PREVOST

**MAINTENANCE
INFORMATION**

Mi01-05

DATE :	May 2001	SECTION :	07 - Transmission
SUBJECT :	MAINTENANCE AND TORQUE OF TRANSMISSION OUTPUT SHAFT YOKE RETAINING BOLT

FIGURE 1

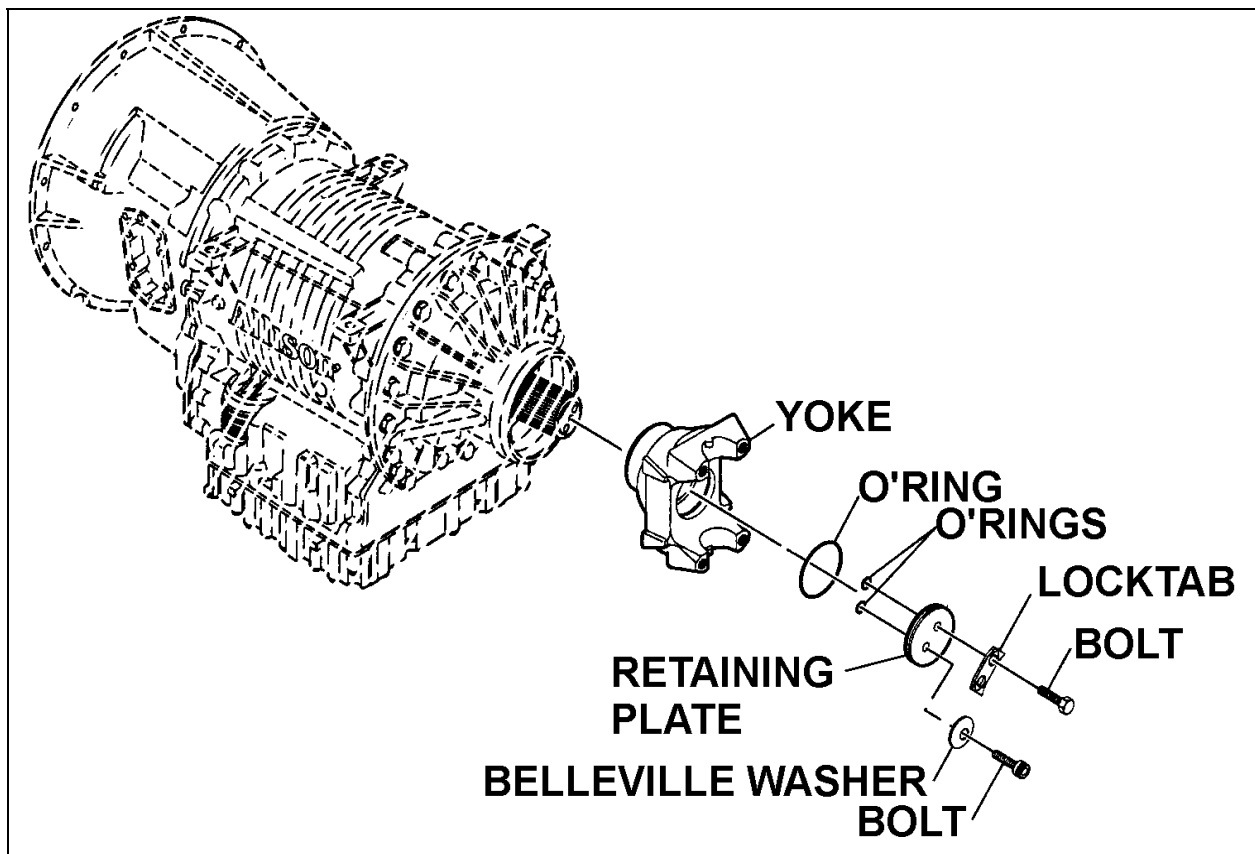
4. Check the torque of output shaft yoke retaining bolt(s). Proper torque depends on the design (one or two bolts). Refer to figure 3.
5. If replacement of two-bolt design hardware or lock tab is necessary, replace prior design head bolts with Allen head service bolt and replace lock tab with Belleville washer. Allen head bolts and Belleville washers **MUST** be used together. Lock tab and Belleville washers **MUST NOT** be used together. Tighten bolts to 30-35 Nm (22-26 lb ft). Refer to figures 1 and 2.

FIGURE 2

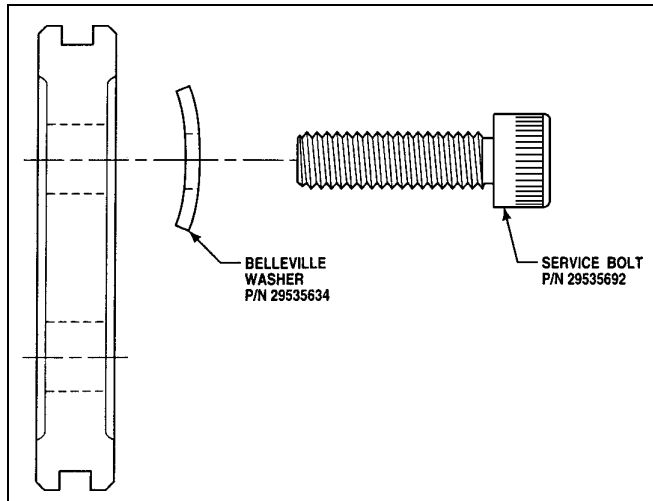
Note: Coned end of Belleville washers **MUST** contact the head of the bolt. Refer to figure 2. Lock tab **MUST NOT** be used with the service bolt and Belleville washer.

FIGURE 3

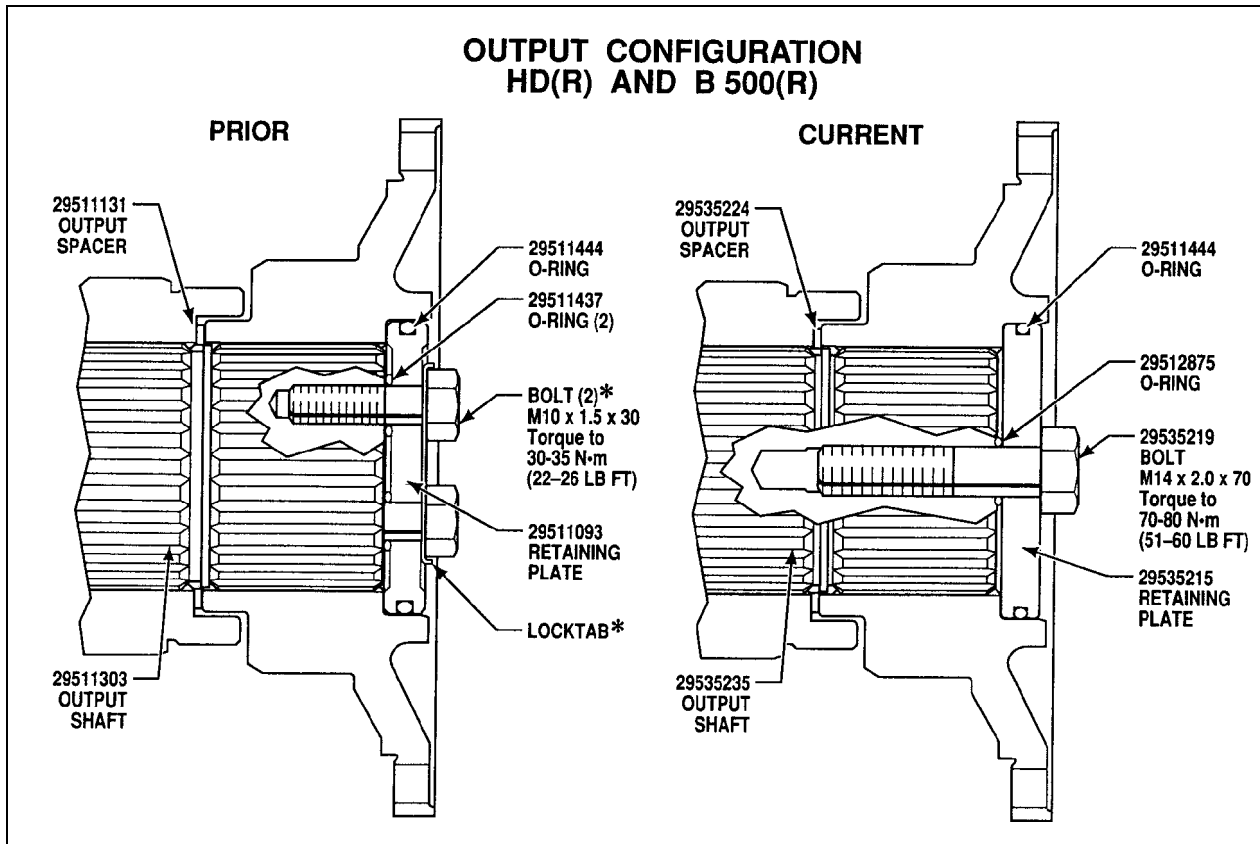
6. If during a transmission rebuilt the output shaft needs replacement, you must use the one bolt design hardware. The former design is no longer available. Refer to figure 3.
